# ISC-C1 Rack

Title <b>ISC System Wiring Diagram</b>		
Size B	Number <b>D1900511</b>	Revision <b>v1</b>
Date: 10/21/2020	Sheet of 1 TBD	
File: C:\Users\...ISC_C1_SHL.SchDoc	Drawn By: Filiberio Clara

# ISCT2 - Left Side

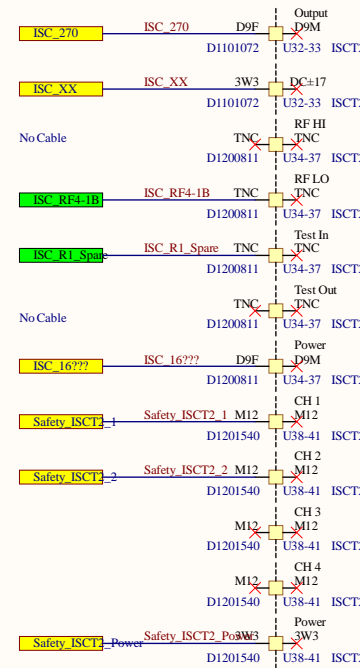
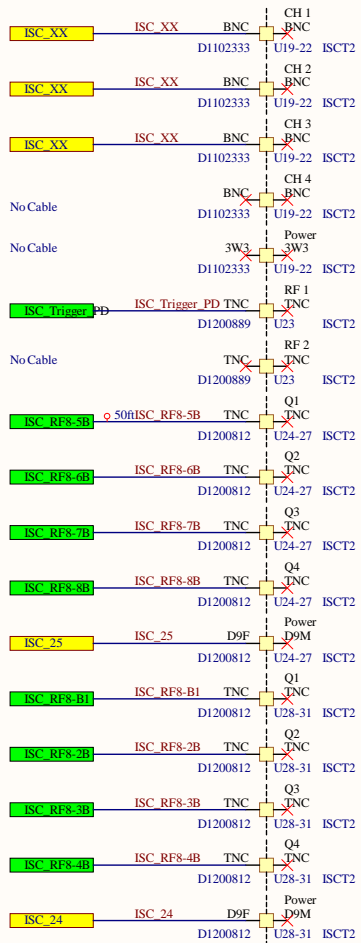
Cable labeled ISC\_16, but label already used.

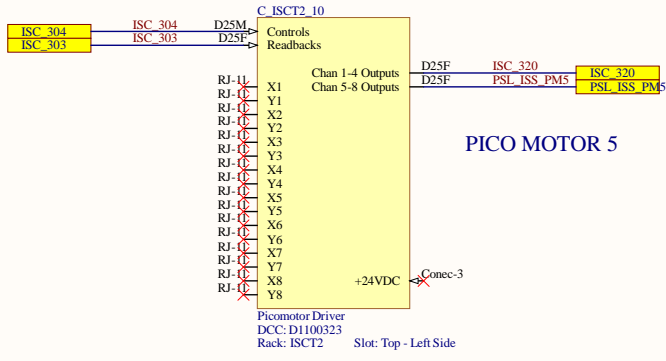
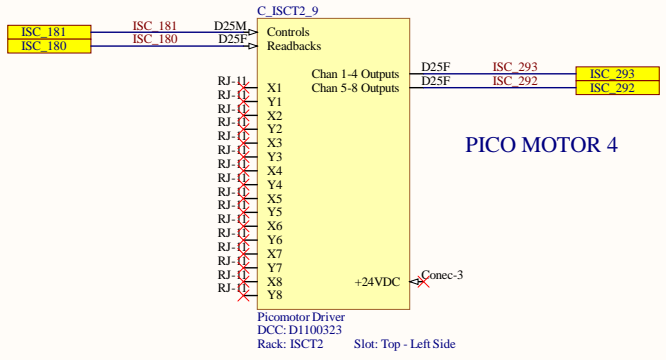
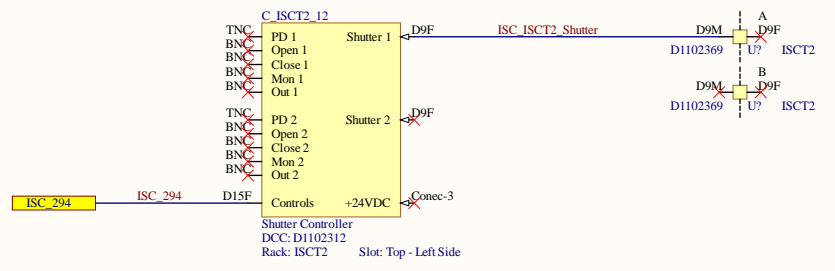
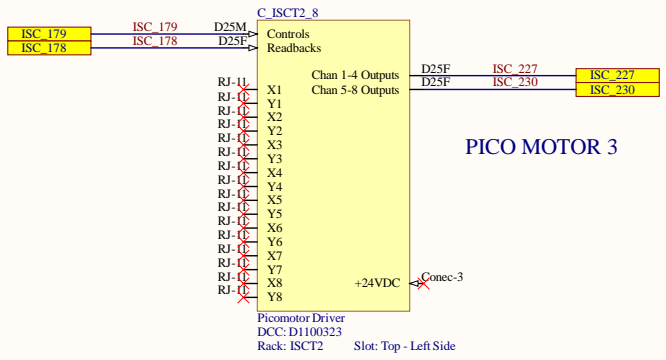
Recheck cable number ISC\_243 or ISC\_320

# HAM6 Flange Layout

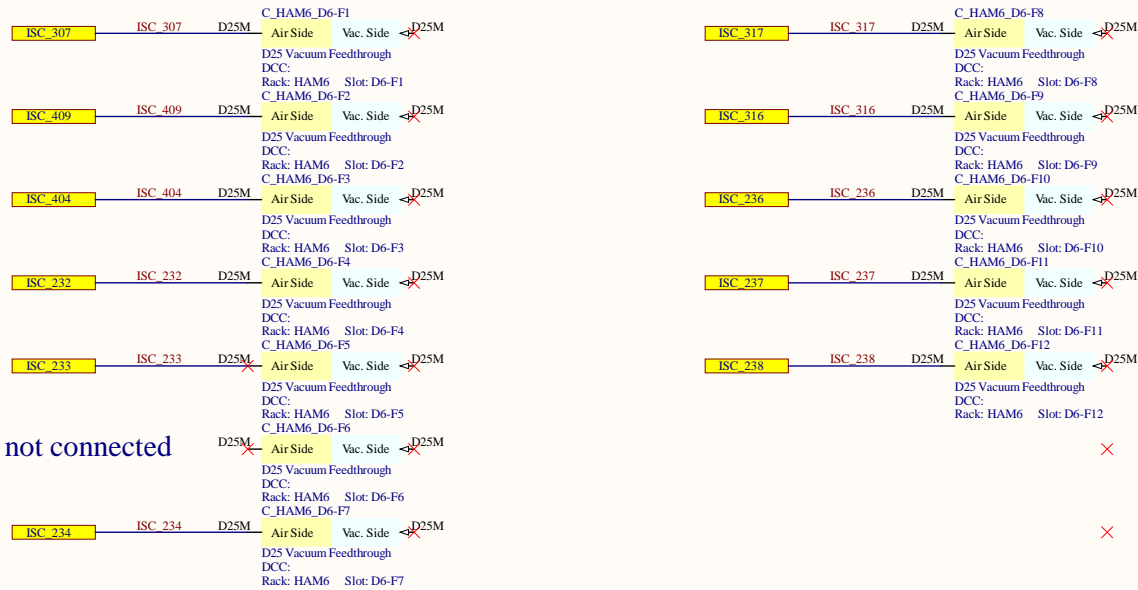
Cable ISC-235 not connected

Cables ISC\_265 & ISC\_266 on SQZ WFS Page  
Recheck flange ????

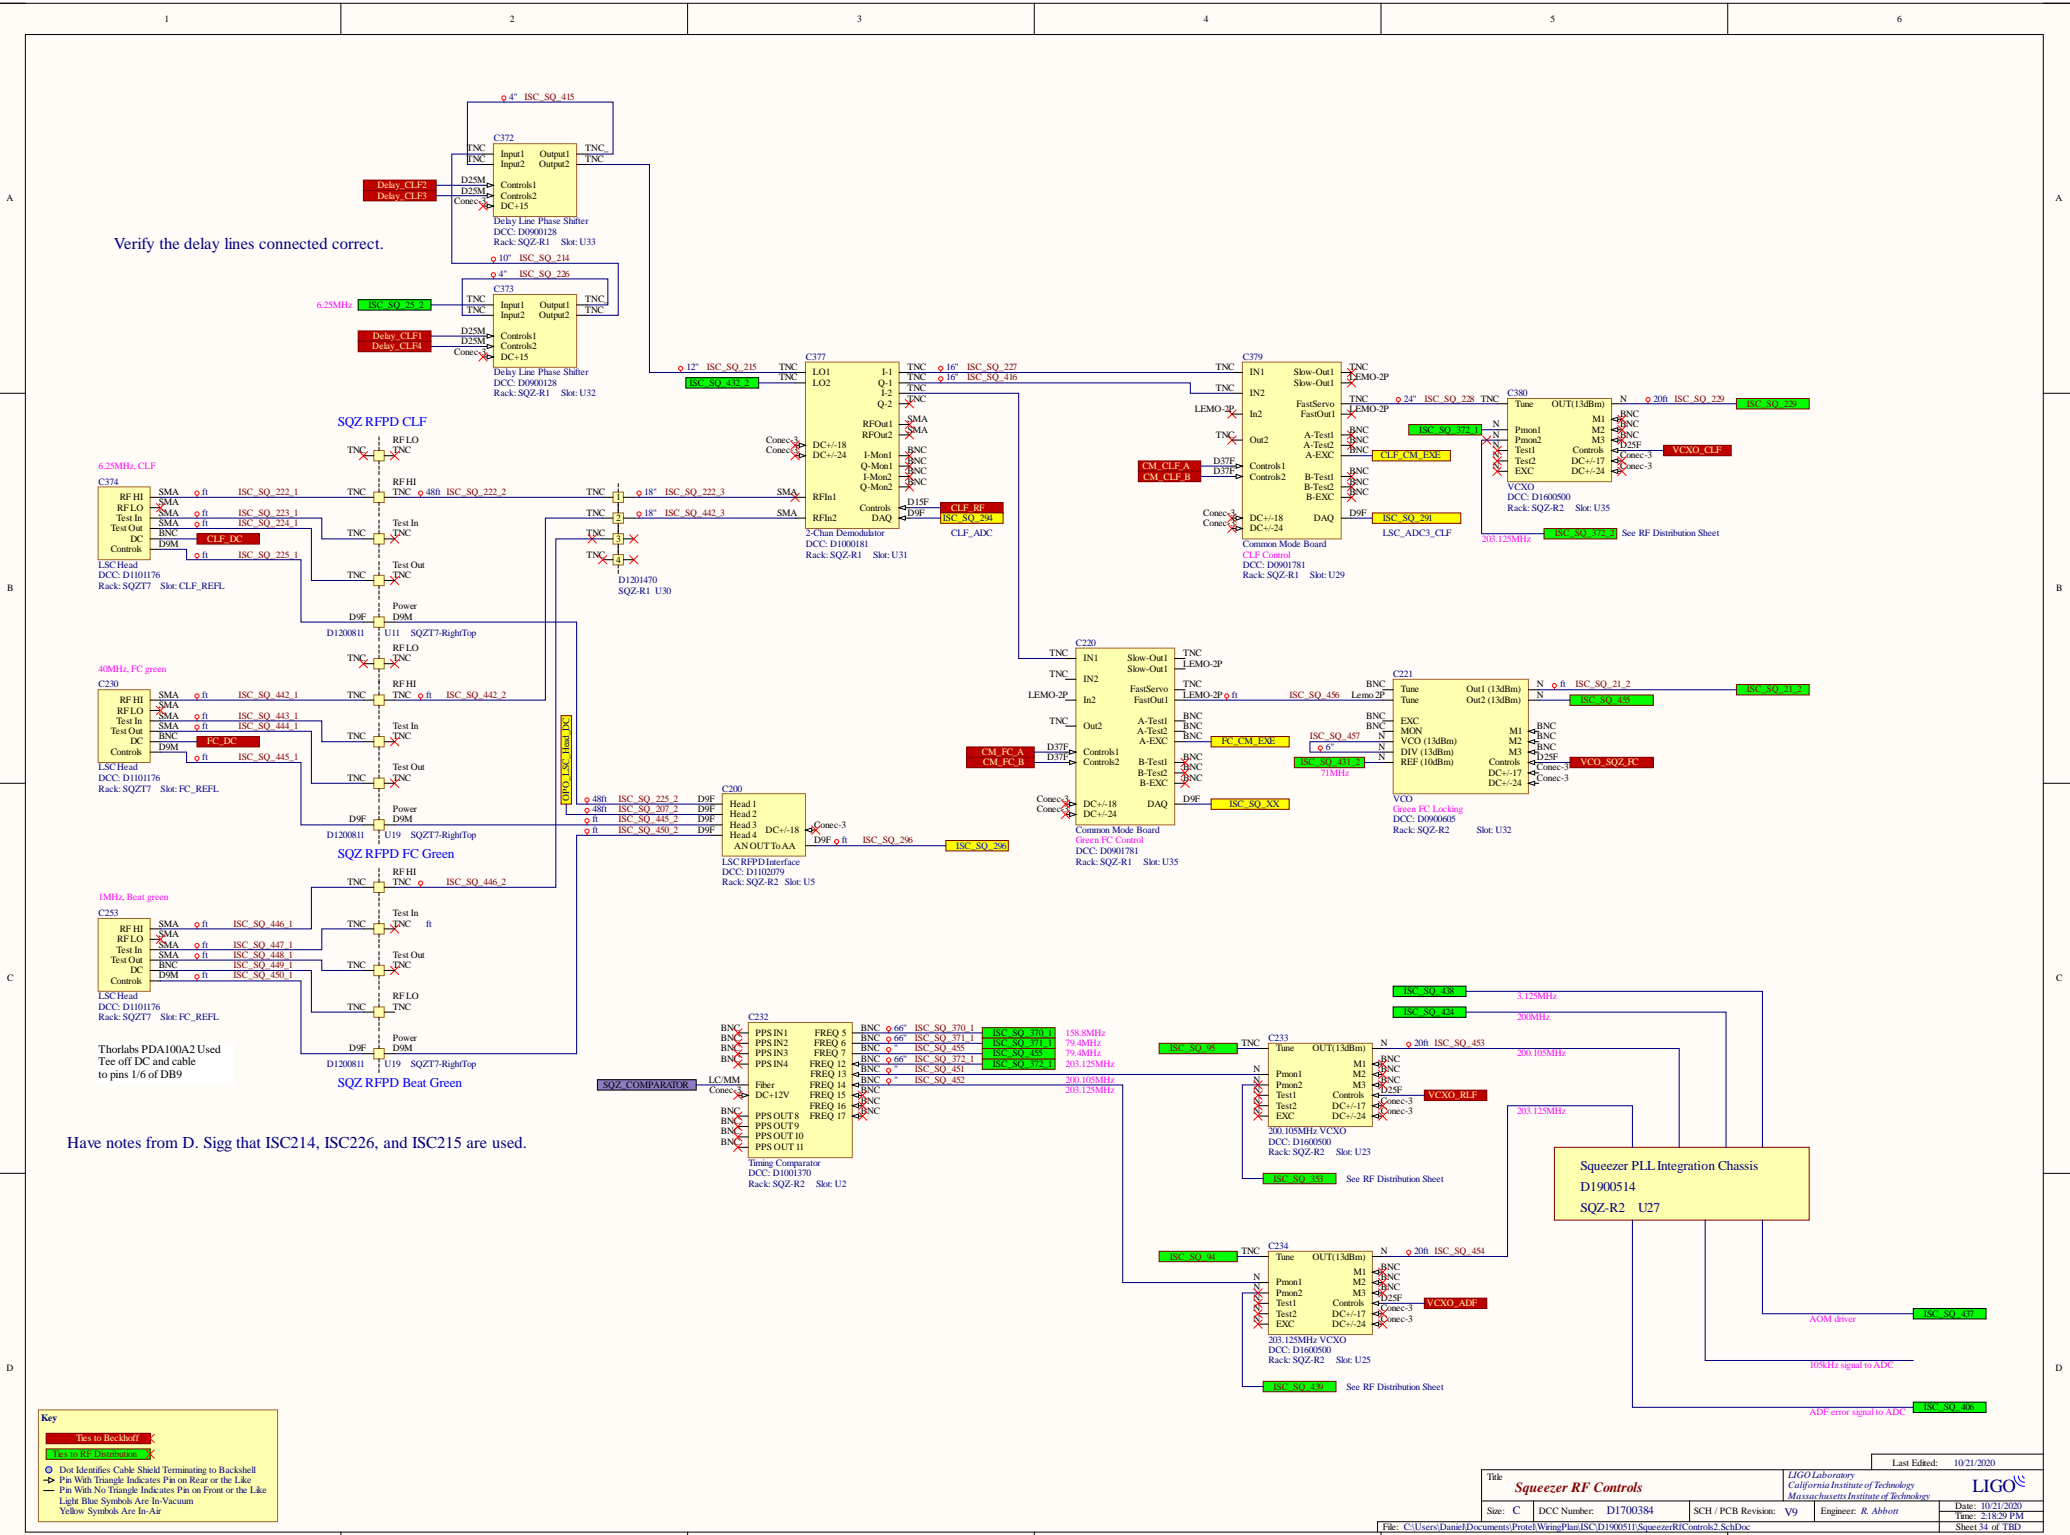
Verify the delay lines connected correct.

Have notes from D. Sigg that ISC214, ISC226, and ISC215 are used.

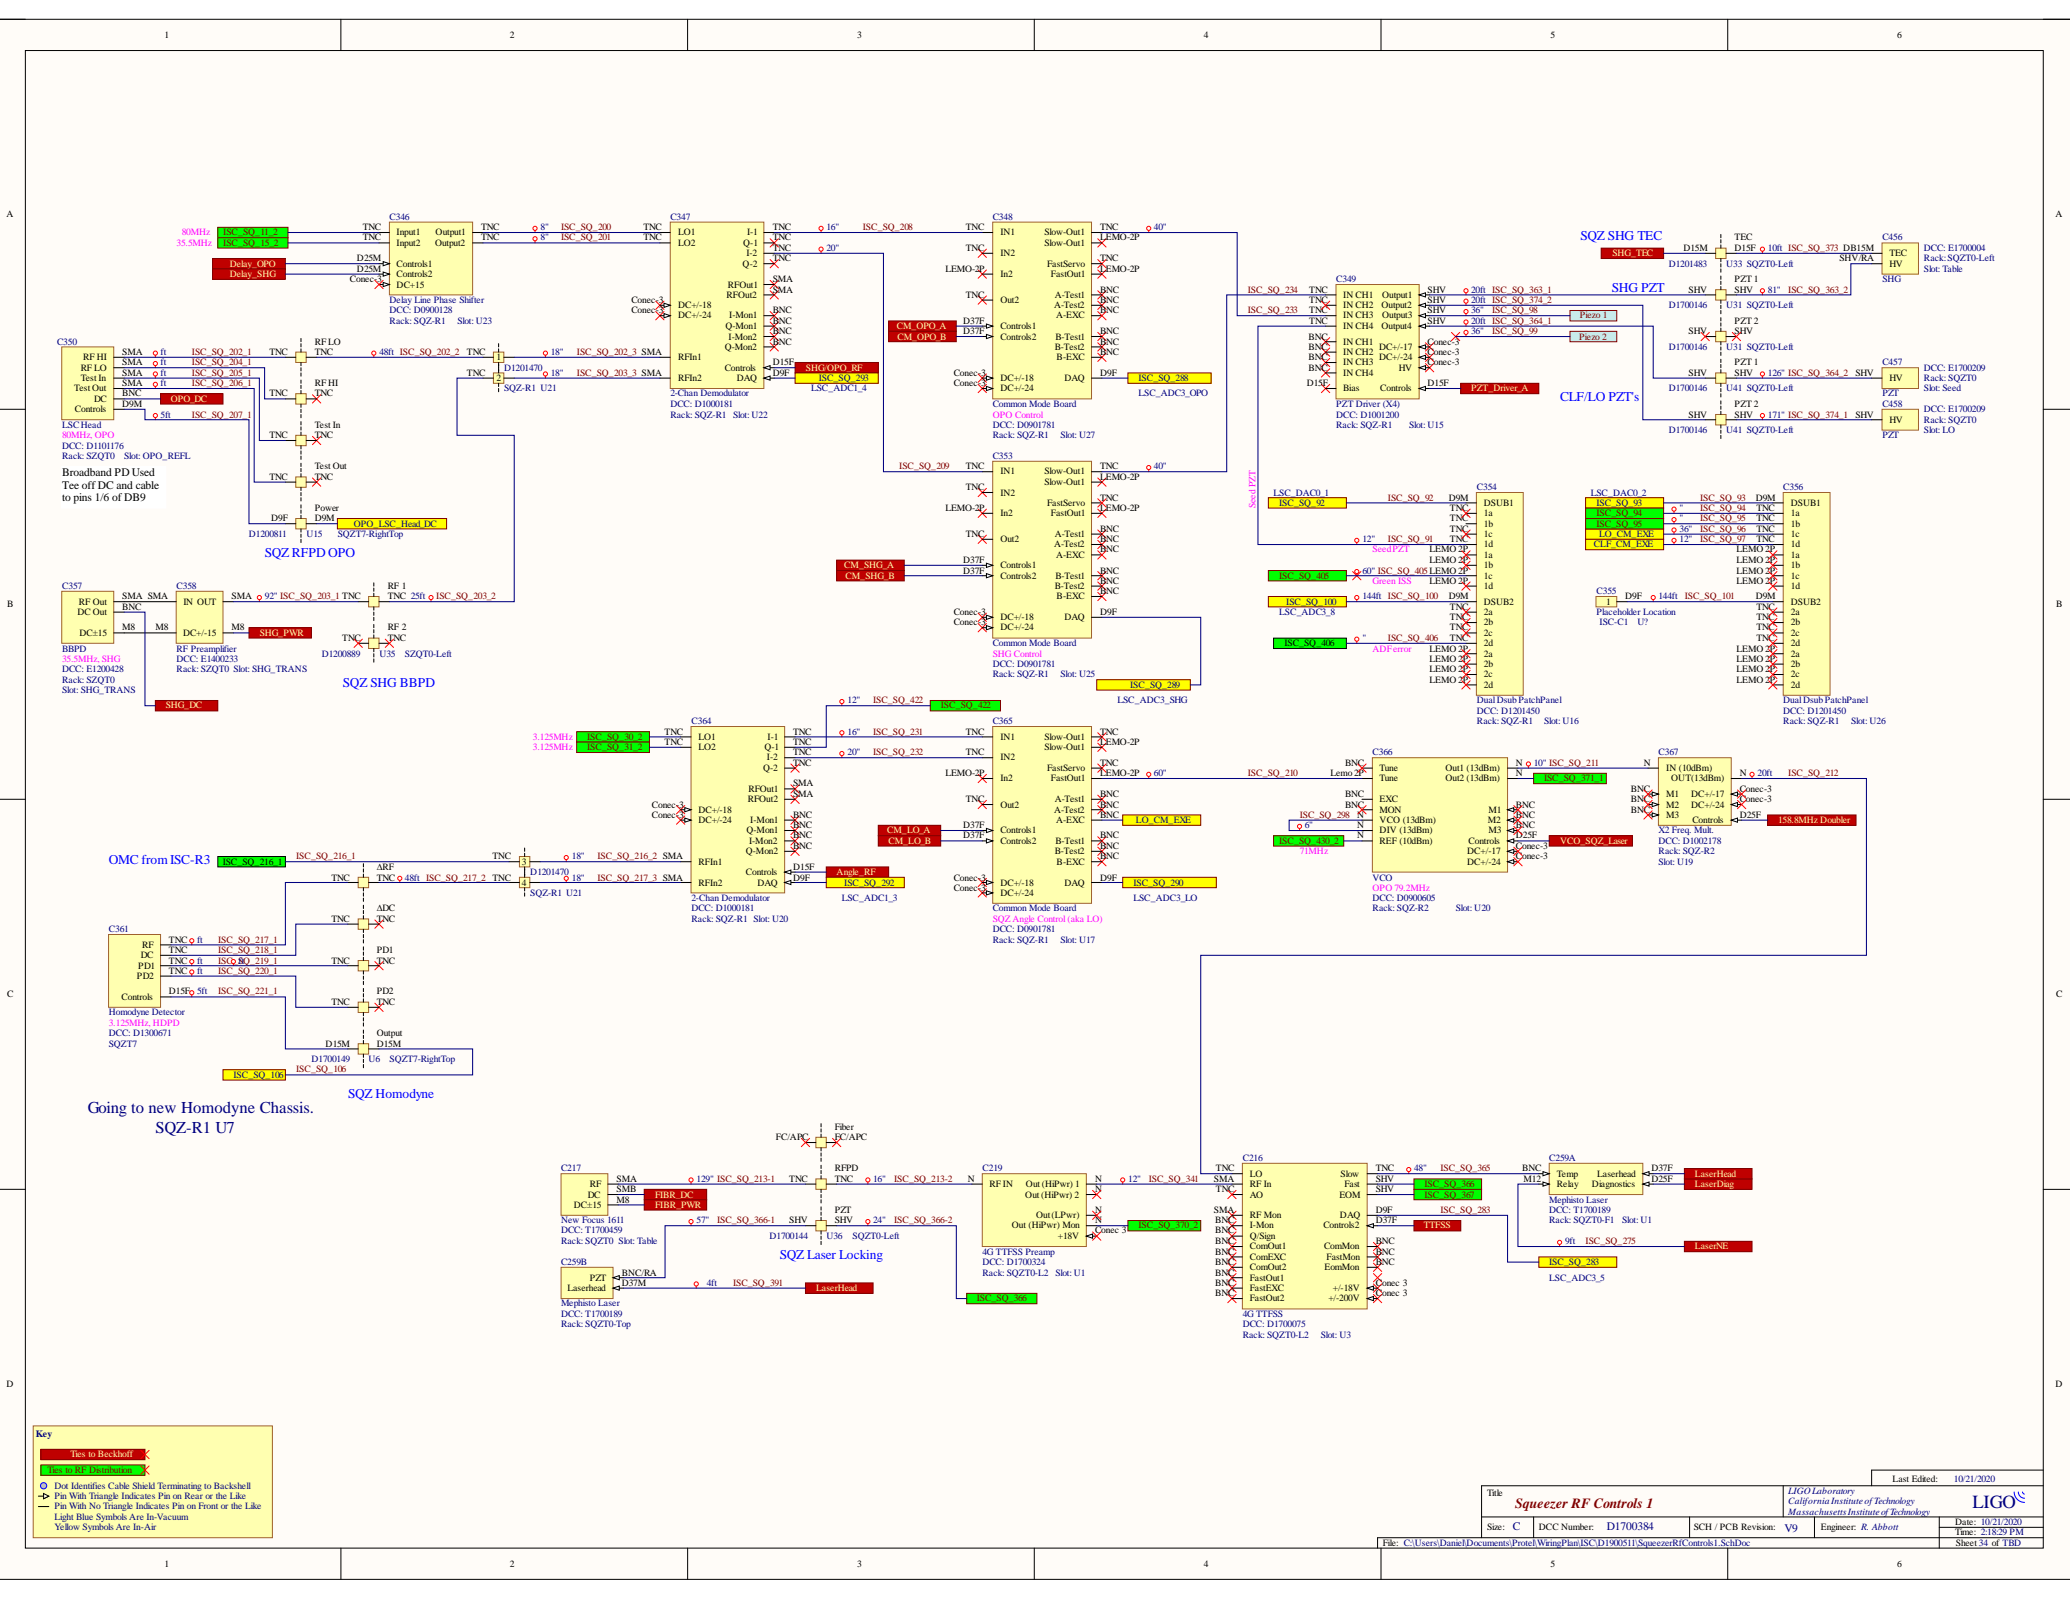
There are no WFS in HAM7!  
So, there are 2 QPDs
